Docket Number:	16-SPPE-01
Project Title:	AltaGas Pomona Energy
TN #:	211667
Document Title:	PRP Data Responses, Set 1A
Description:	Responses to Data Requests 1 to 45
Filer:	John Carrier
Organization:	CH2M HILL
Submitter Role:	Applicant Consultant
Submission Date:	5/27/2016 1:48:27 PM
Docketed Date:	5/27/2016

Subject: Data Response, Set 1A
Pomona Repower Project (16-SPPE-01)

Pomona Repower Project

Data Responses, Set 1A

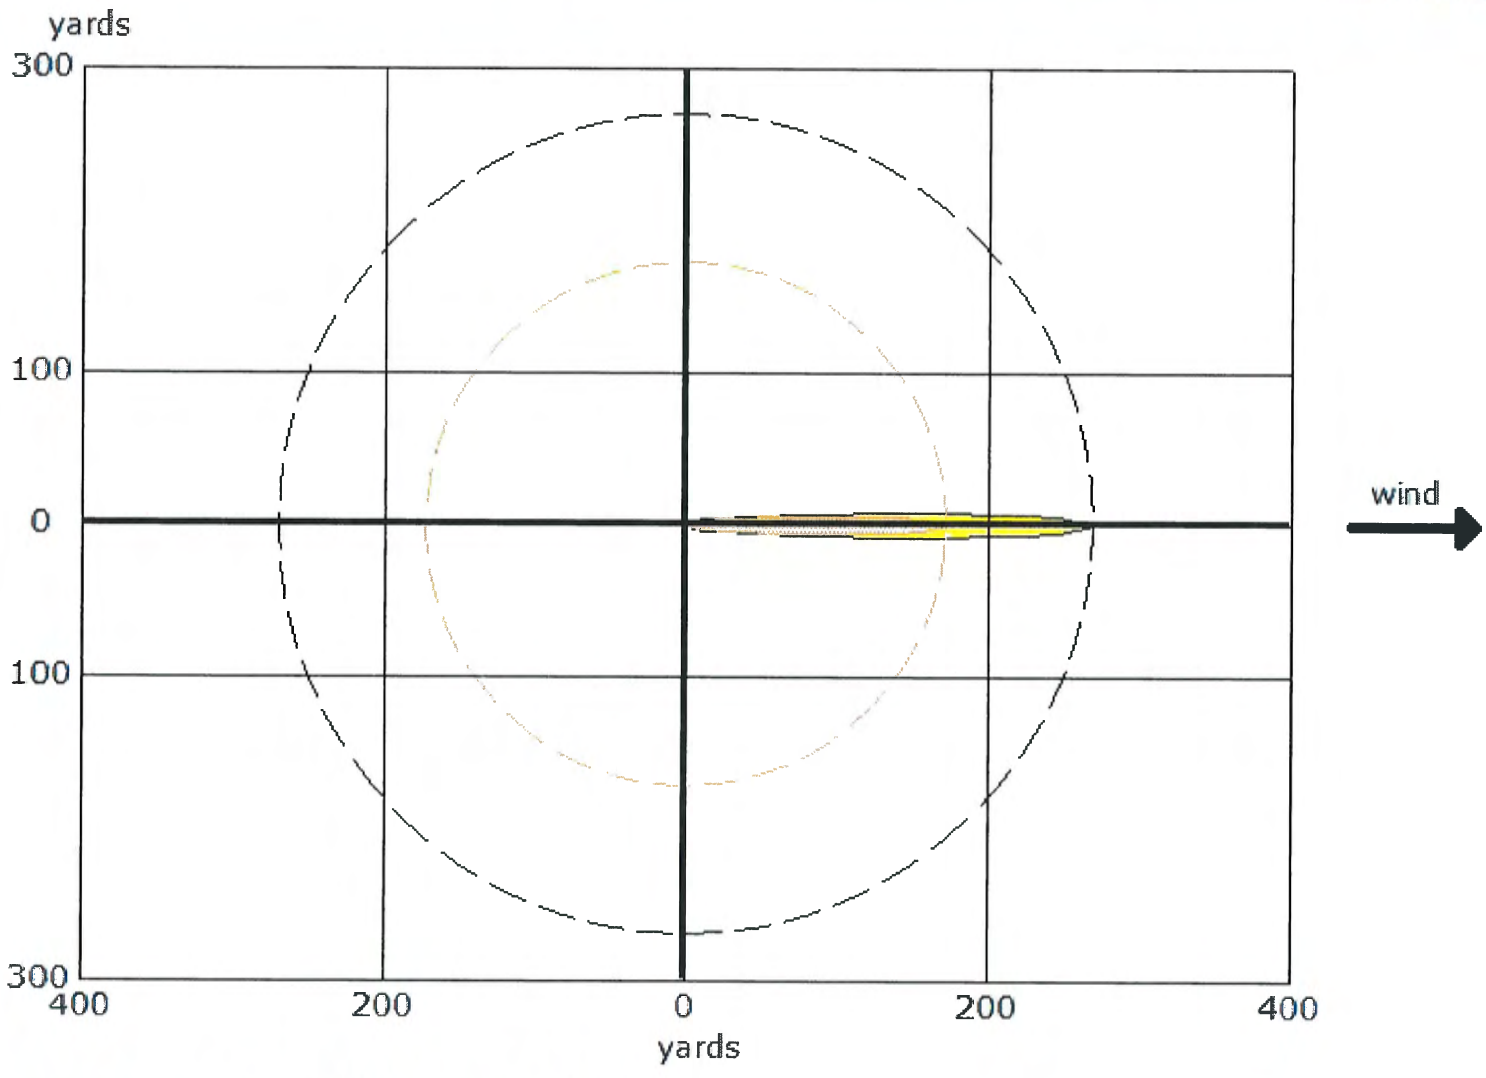
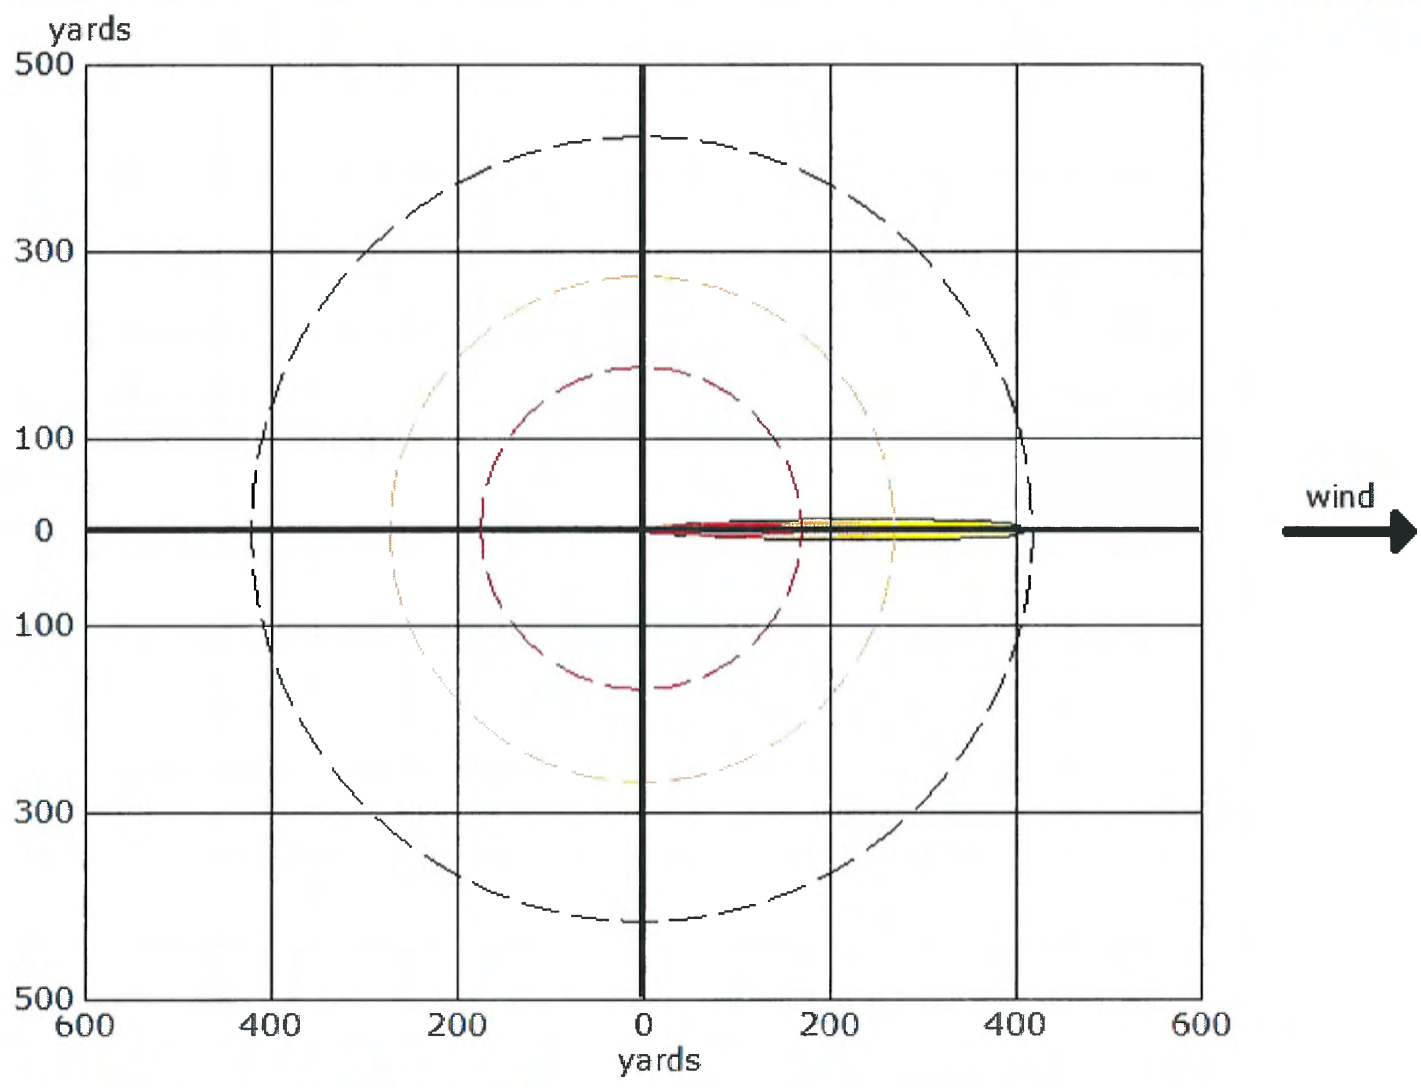
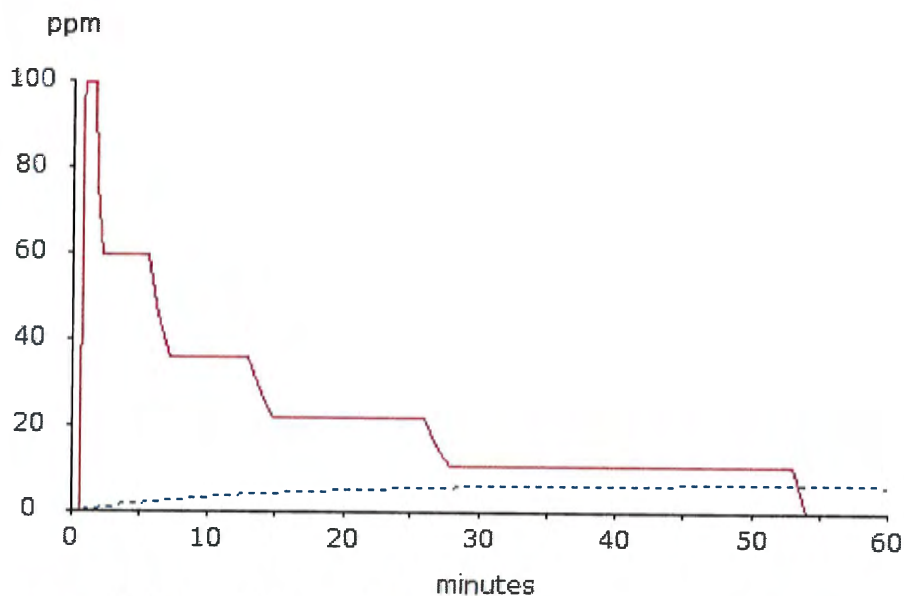
17. Please provide a worst case OCA to determine the impact to the surrounding community.

Response: In Applicant's May 13, 2016 letter, the Applicant objected to this data request as not reasonably necessary for the Commission decision in this proceeding since it ignores the baseline condition under CEQA. Without waiving this objection, Applicant has prepared an Offsite Consequence Analysis, which is provided as Attachment DR17-1.

The proposed ammonia storage tank's secondary containment basin is approximately 33 feet to the west of the plant's closest boundary; the closest residence is approximately 870 feet to the north. The results of the OCA for the worst-case release scenario of ammonia at PRP indicates that concentrations exceeding the benchmarks above would extend beyond the project boundary, but only the CEC significance value of 75 ppm would extend beyond the distance to the nearest resident.

The results for the alternative release scenario (i.e., loading spill) show that concentrations exceeding the benchmarks above would extend beyond the project boundary, but not far enough to impact any residential receptors.

FIGURE 2.1-4R1
One-line Diagram of Electrical System
 Pomona Repower Project
 Pomona, California

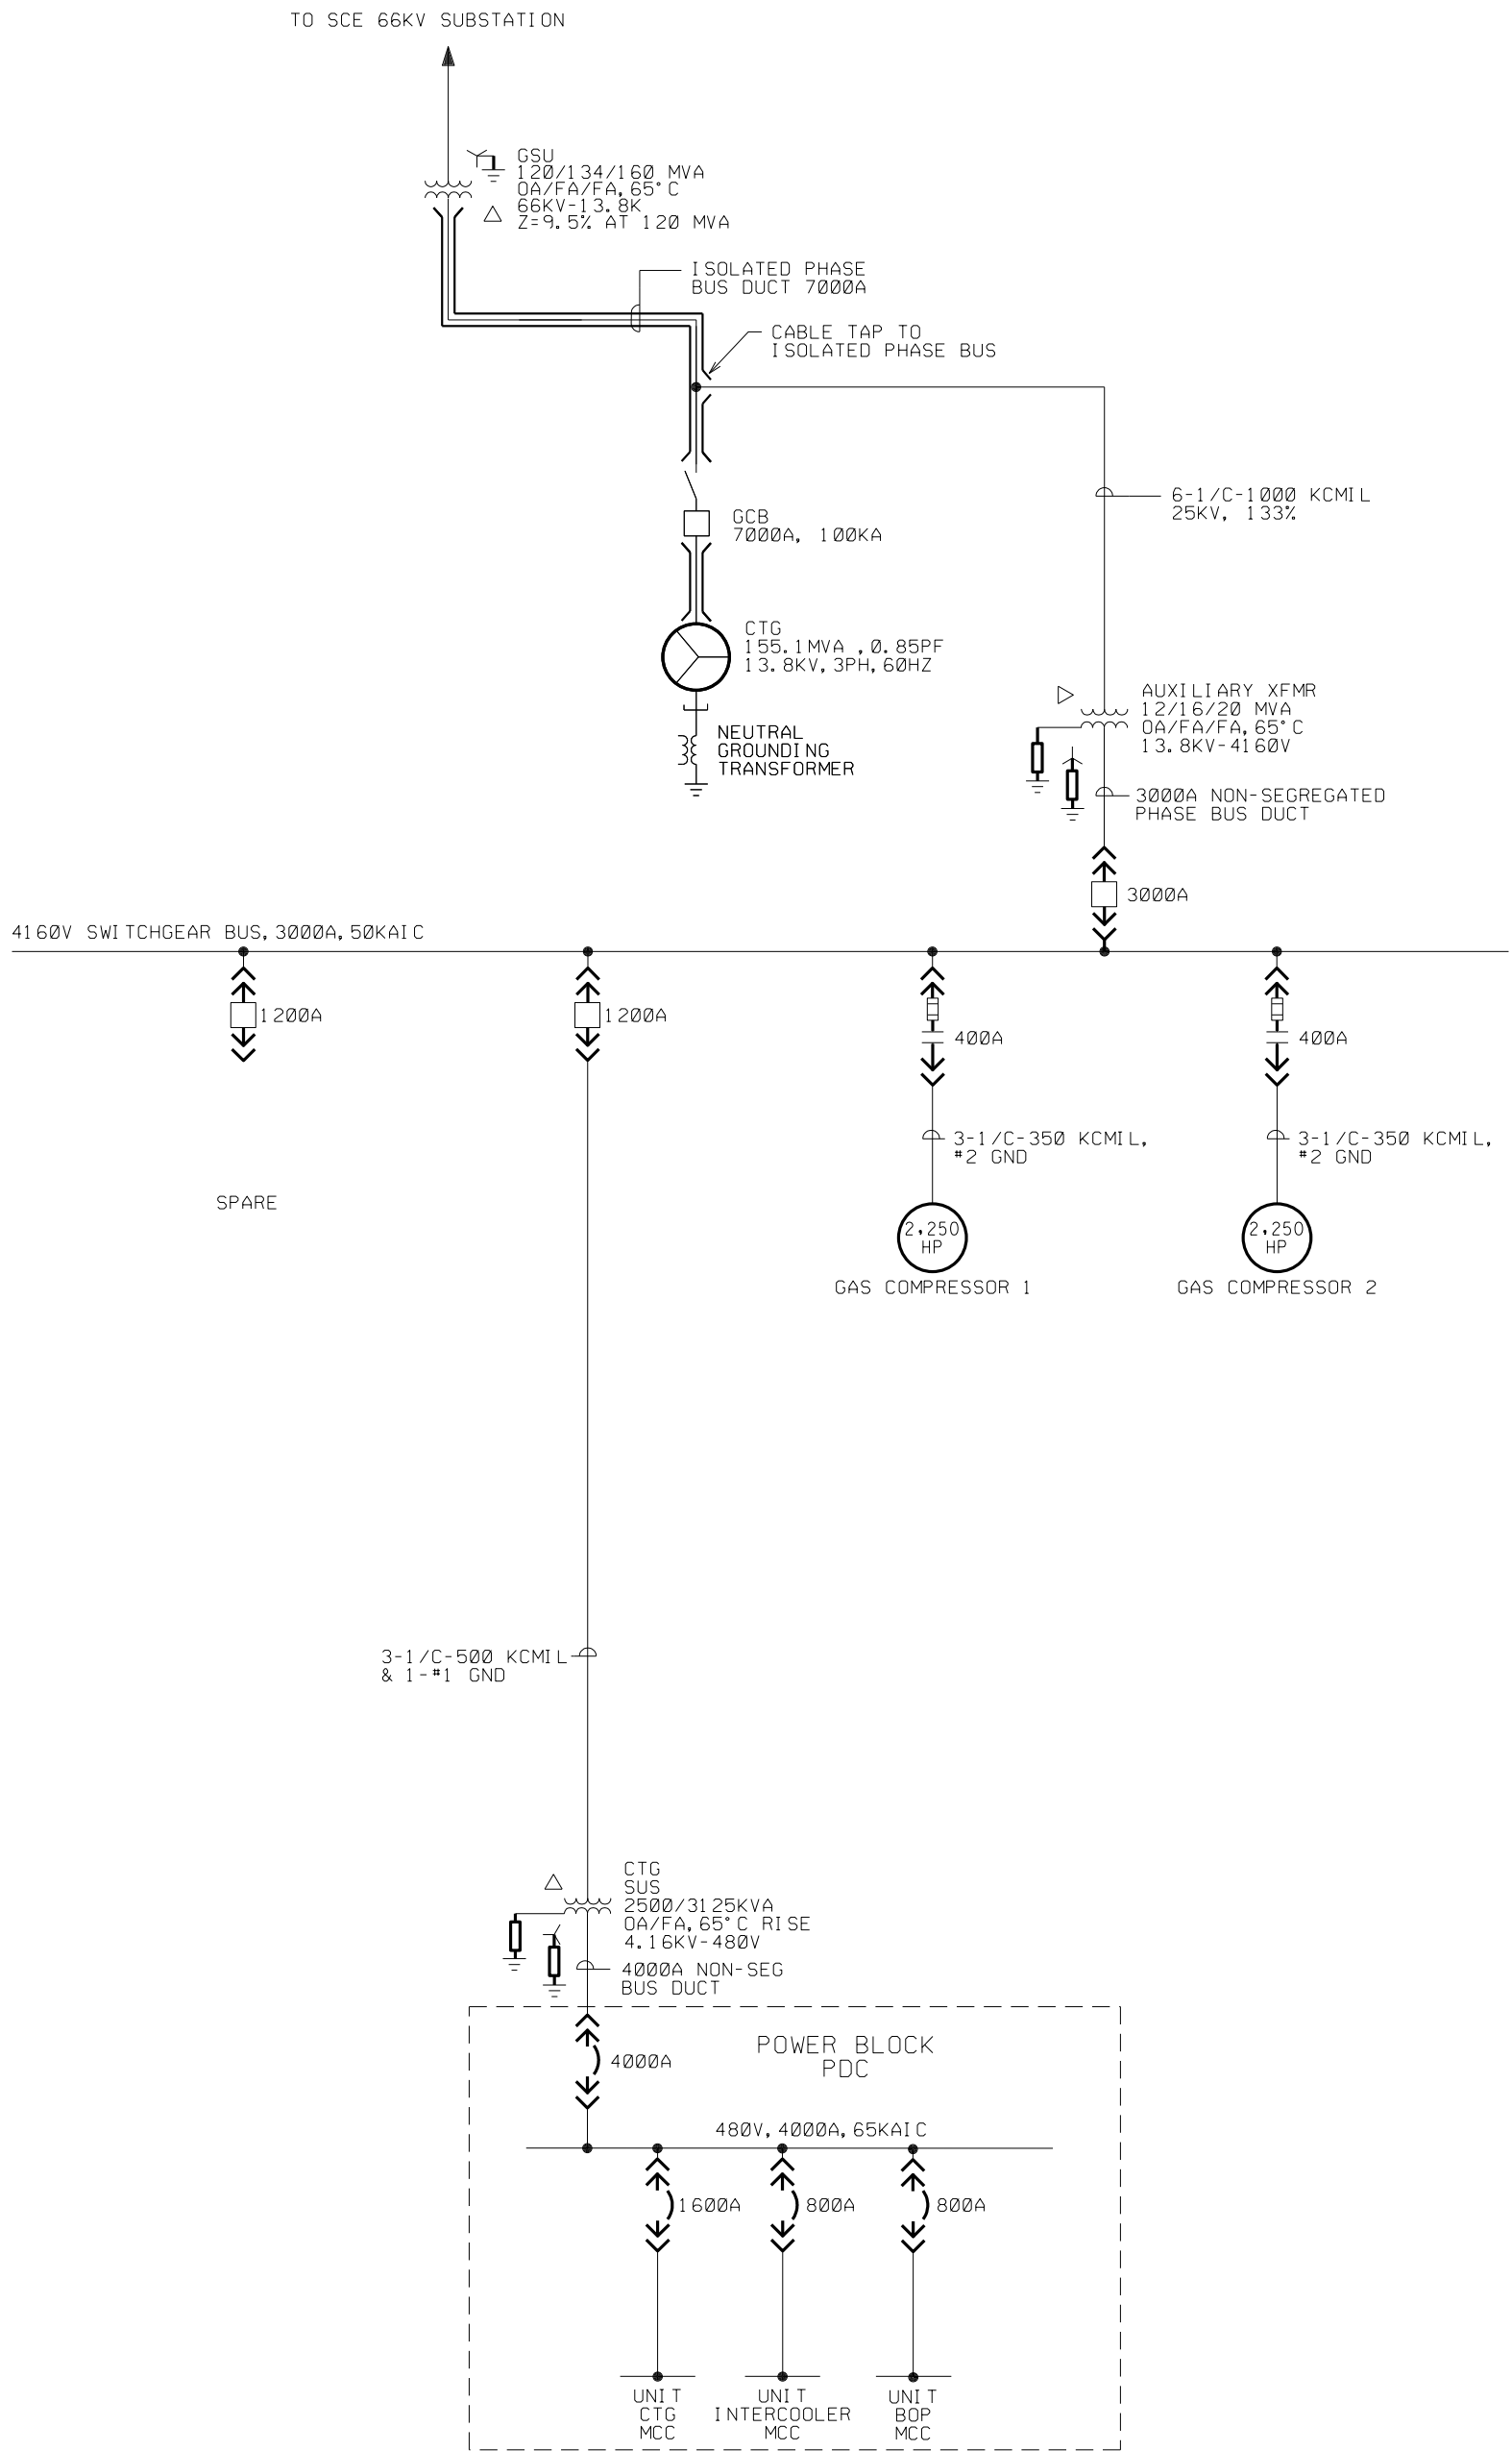
34. Resubmit Figure 2.1-4. Show all equipment ratings including generators, transformers, isolated phase bus, circuit breakers, disconnect switches, etc., that are required for the project.

Response: The one-line electrical diagram has been revised and is attached as Figure 2.1-4R1.
